PHAP14-00029

Date: October 20, 2014
Application Type: Certificate of Appropriateness
Property Owner: Ricardo Chavez
Representative: Ricardo Chavez
Legal Description: Being 46 Ysleta Tract 5 .1702 Acre, City of El Paso, El Paso County, Texas
Historic District: Ysleta
Location: 220 Candelaria Street
Representative District: #6
Existing Zoning: R-4/H (Residential/Historic)
Year Built: 1940
Historic Status: Non-Contributing
Request: Certificate of Appropriateness for the for the removal and replacement of windows, doors, and window surrounds after the fact
Application Filed: 10/6/2014
45 Day Expiration: 11/20/2014

ITEM #3

Certificate of Appropriateness for the removal and replacement of windows, doors, and window surrounds after the fact

OLD AND NEW WINDOWS

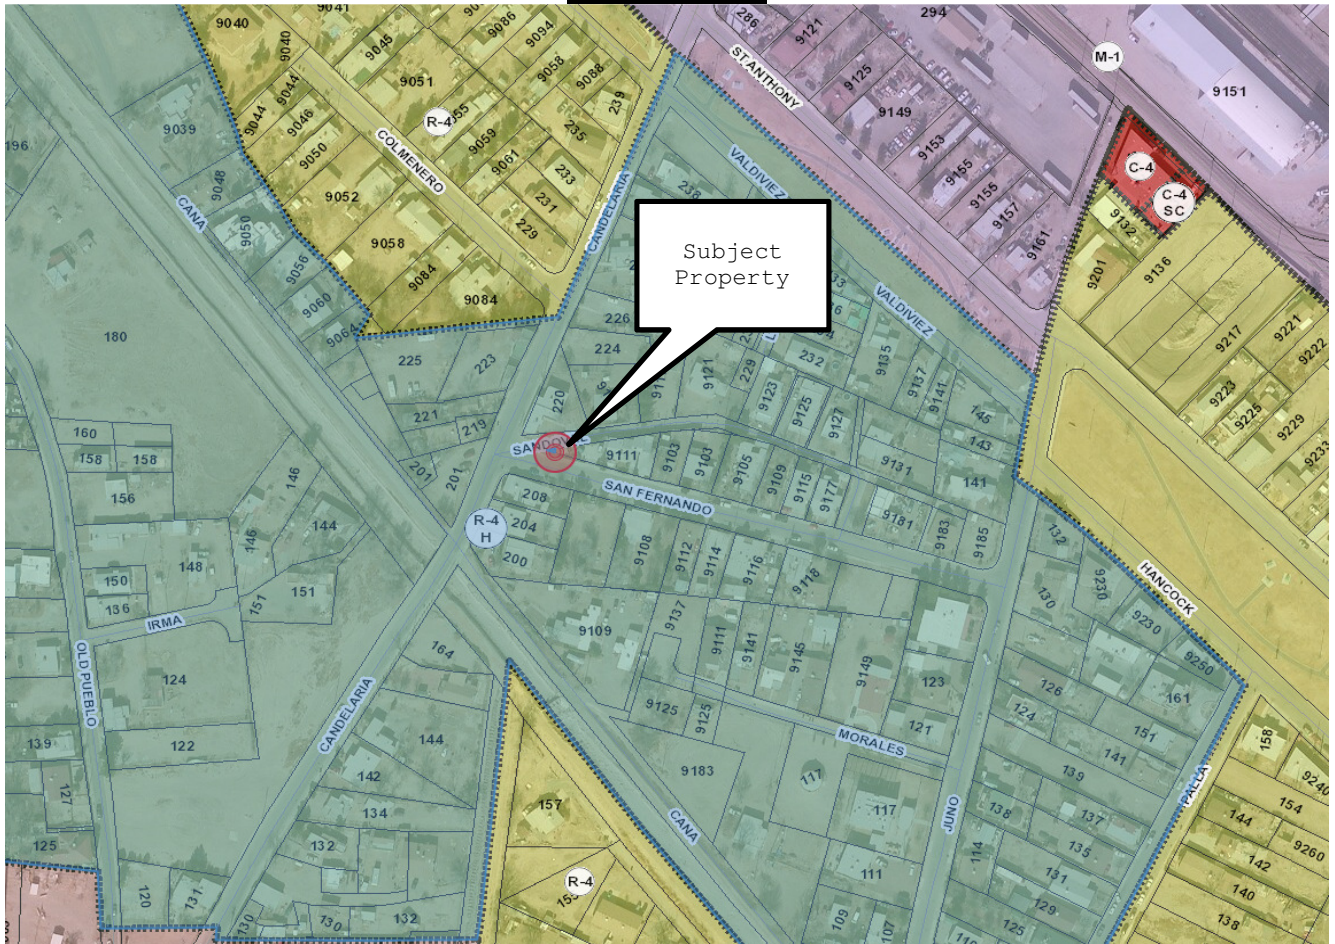
The Historic Preservation Office recommends DENIAL of the proposed scope of work based on the following recommendations:

- *Windows should be repaired rather than replaced. In most cases this will simply entail removing old paint, installing new weather stripping, and then repainting. If windows are damaged beyond repair, replacement windows should match the type, style, material and finish of the original. Do not plug, cover, and/or widen windows if they are on the exterior walls of the original structure.*

- *Aluminum sliding windows are not in character with the Ysleta Historic District. Muntins should be installed on existing horizontal windows, so as to create the appearance of true divided light.*
